**12-D-21-HZ**  
**APPLICATION FOR CERTIFICATE OF APPROPRIATENESS**

**2106 Jefferson Ave. 37917**  
**Edgewood-Park City H**

Original Print Date: 12/7/2021  
 Knoxville/Knox County Planning -- Historic Zoning Commission

### Level III Construction of New Primary Building

FRONT ELEVATION

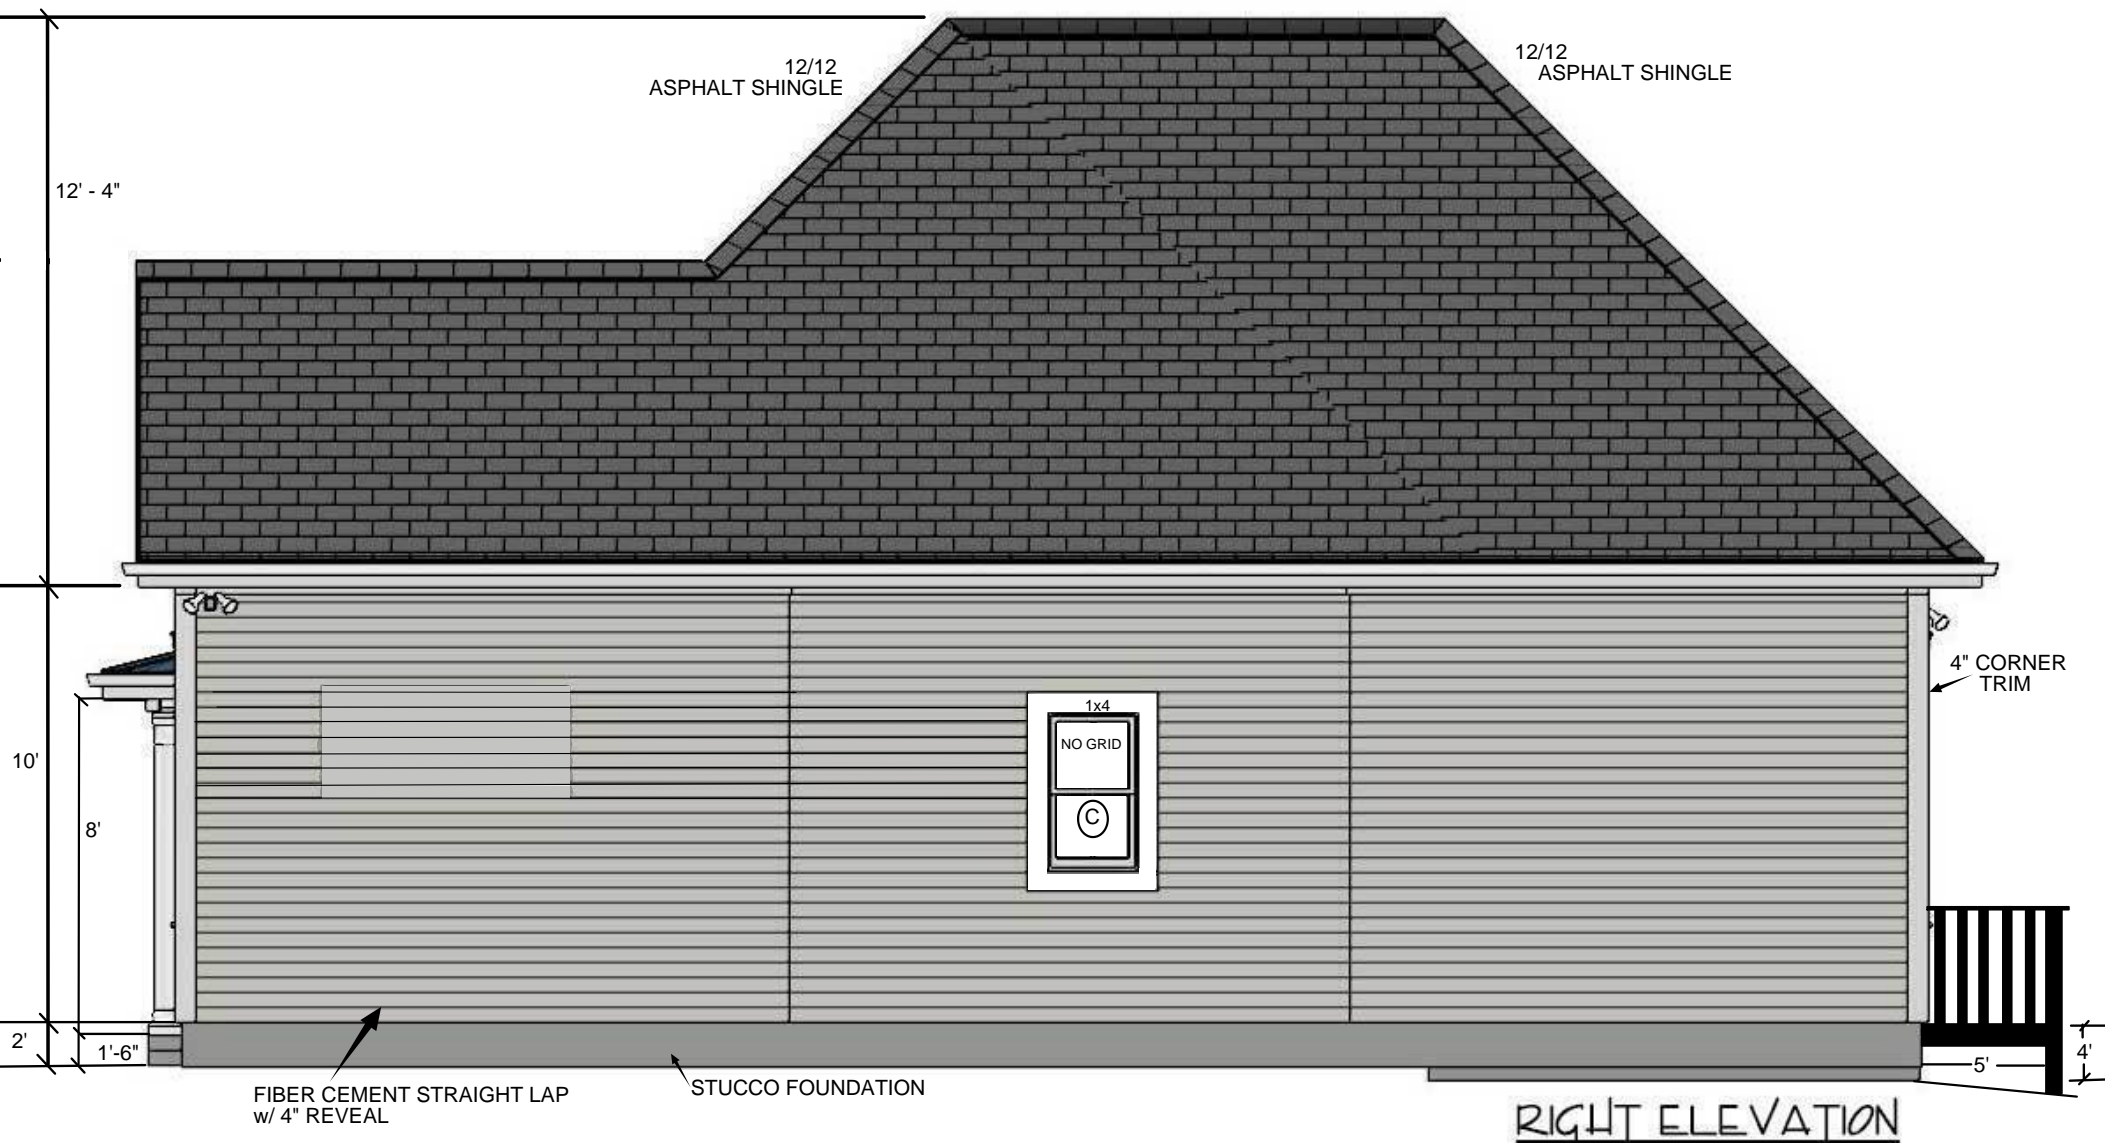
1. The house is proposed to be set 13' from the front property line. The average of the blockface is 18'. The front setback should be adjusted to conform to base zoning requirements and be aligned with the adjacent properties. The projecting front-gable massing and porch will assist in creating a consistent front yard space. The house will be placed at a consistent angle to the street with the other houses.

7. The porch is a unique element in the proposed design. The porch materials (square 8" composite columns, wood flooring, beadboard ceiling) do meet the design guidelines. While a round projecting corner porch is not inappropriate for the context, and could contribute a unique contemporary element to the design, the porch's roof form does not have historic precedent or relate to new buildings. The porch roof structure (asphalt shingle-clad section projecting out from the main house, with empty roof space above the round standing-seam section) is somewhat disproportionate. The porch design should be revised, pending recommendations from the Commission, and the Commission may decide if the revision could be approved by staff or return to the HZC.

9. The front elevation incorporates a "strong sense of entry" recommended by the design guidelines. The proposed Craftsman-style door is inconsistent with the Queen Anne cottage form; a door more appropriate for the style should be selected (one-half-light, two-thirds-light, full-light). Fiberglass doors are appropriate for new construction, if they are smooth-finished.

10. The proposed windows (one-over-one, double-hung wood) meet the guidelines for materials. Guidelines recommend designing new construction with consistent placement of door and window openings, with the intent of achieving sufficient transparency on all elevations. Proposed window placement on the façade is consistent with the historic context; the canted corner window is a unique form, but does not detract from the overall design of the house and contributes complexity to the façade. 1-2 additional windows are necessary on the right (west) elevation to avoid large swaths of siding with no transparency.

11. The applicant has incorporated simple but historically-appropriate window trim on the façade windows. Instead of the flat "picture frame" trim with no sills proposed for the side and rear windows, the façade window trim (or at least, the addition of window sills) should be incorporated in all windows.

- 1) Final site plan and parking to meet City Engineering standards, with modifications to be approved by staff;
- 2) Front setback to be modified to be consistent with average of blockface and adjacent properties, final site plan to be approved by staff;
- 3) Select a front door more appropriate for Queen Anne cottage design, with approval by staff;
- 4) Add one or two additional windows to right (west) elevation and apply façade's window trim to all windows (or at least incorporate window sills), with approval by staff;
- 5) Revisions to front porch design; HZC to designate approval by staff or revised design to return to Commission.
